To:	Mary Joy Scala
Of:	City NDS
From:	Clark Gathright
Date:	June 10, 2013
Project:	West Main Residence Inn
CC:

Certificate of Appropriateness Application BAR 12-05-03 301-315 W Main Street Tax Map 32 Parcels 197, 198, 199 Clark Gathright, Applicant/VIM, Inc., Owner

CITY OF CHARLOTTESVILLE **BOARD OF ARCHITECTURAL REVIEW** STAFF REPORT June 18, 2013

Certificate of Appropriateness Application BAR 12-05-03 301-315 W Main Street Tax Map 32 Parcels 197, 198, 199 Clark Gathright, Applicant/VIM, Inc., Owner New 7-story hotel - Details

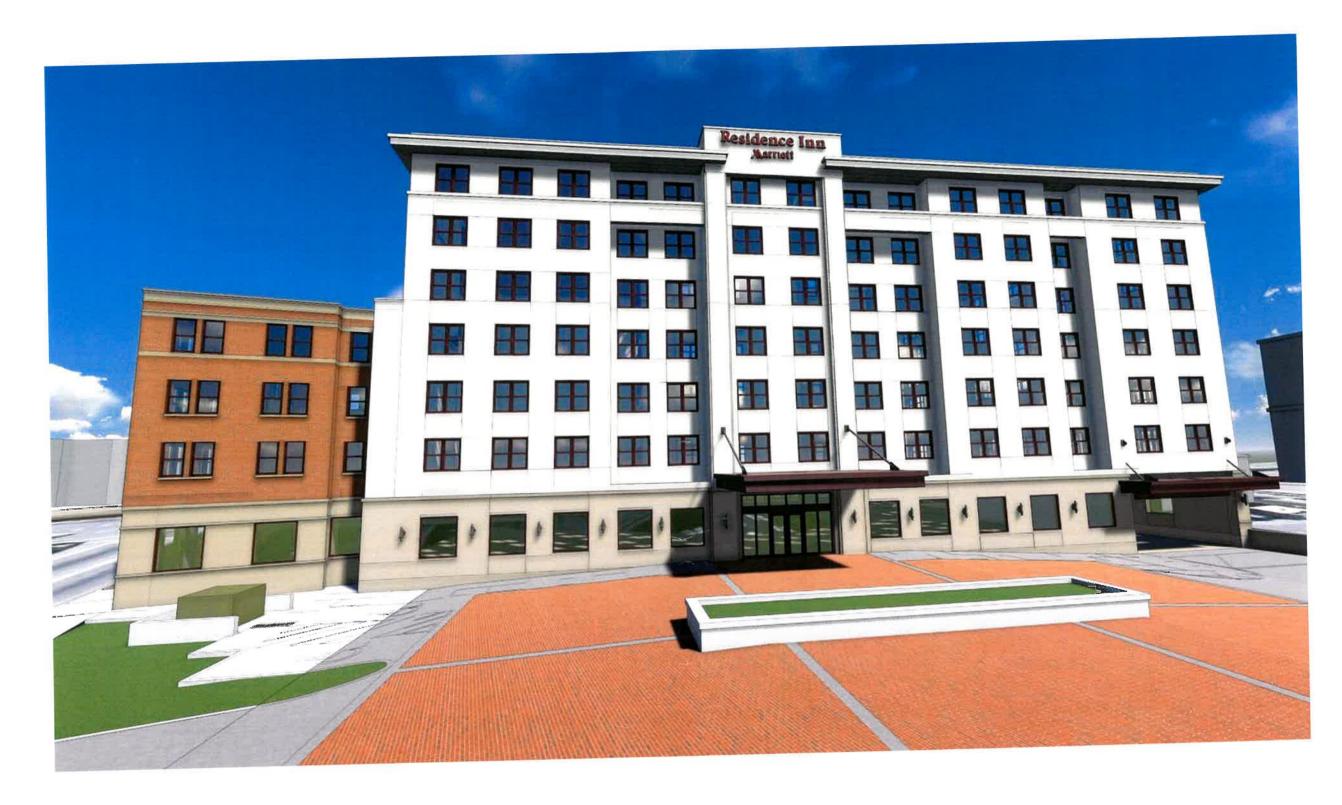
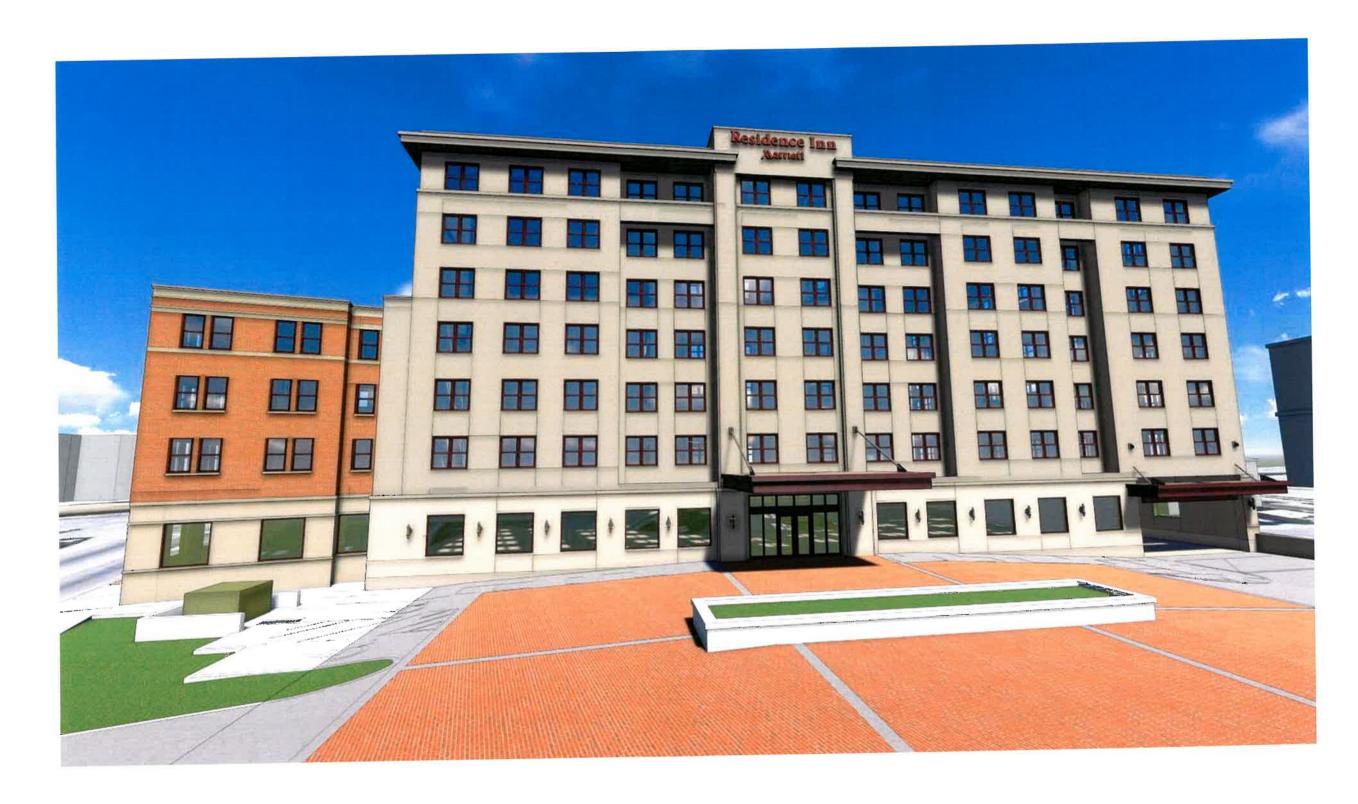
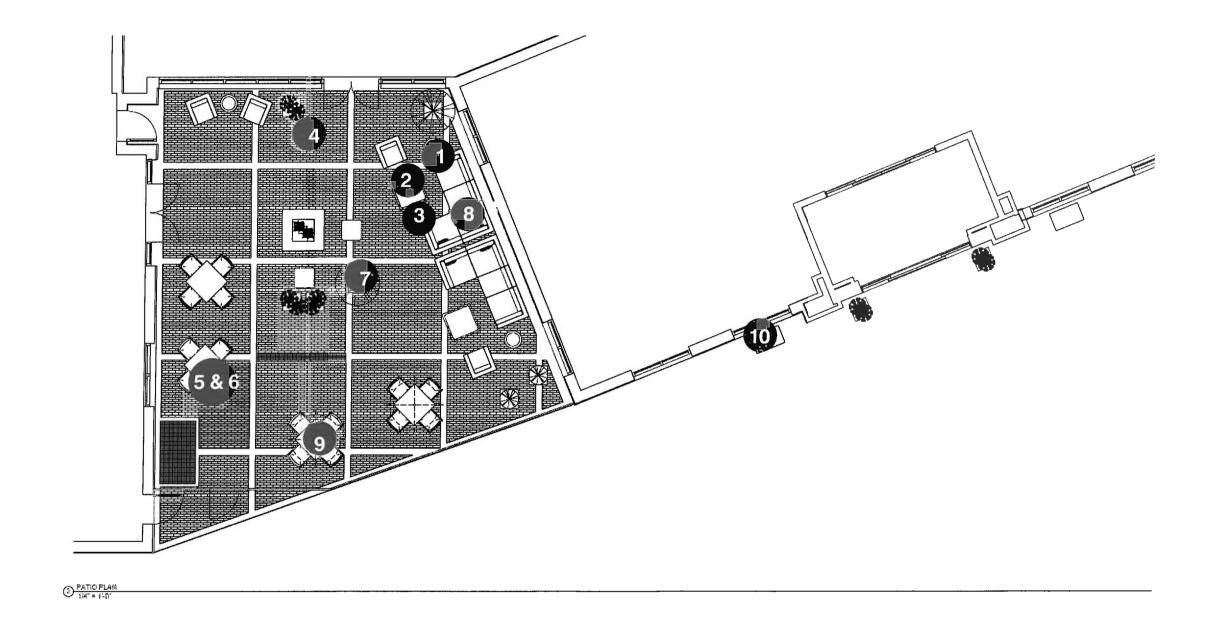
Color of stucco on C building

The applicant proposes two options: Benjamin Moore "Kingsport Gray," a medium brown-gray, or "Cloud White."

Approved (7-0) details as submitted, including: dark color "Kingsport Gray" stucco; suggest more significant plantings in courtyard; make fence minimal (bollard and chains are OK; no gate needed); roof sign is inappropriate (will not be recommended when Comprehensive Signage Plan is submitted); parapet will provide adequate 7th floor roof mechanical screening; submit landscape easement information as part of final site plan approval; lower lighting levels in parking lot as much as possible.
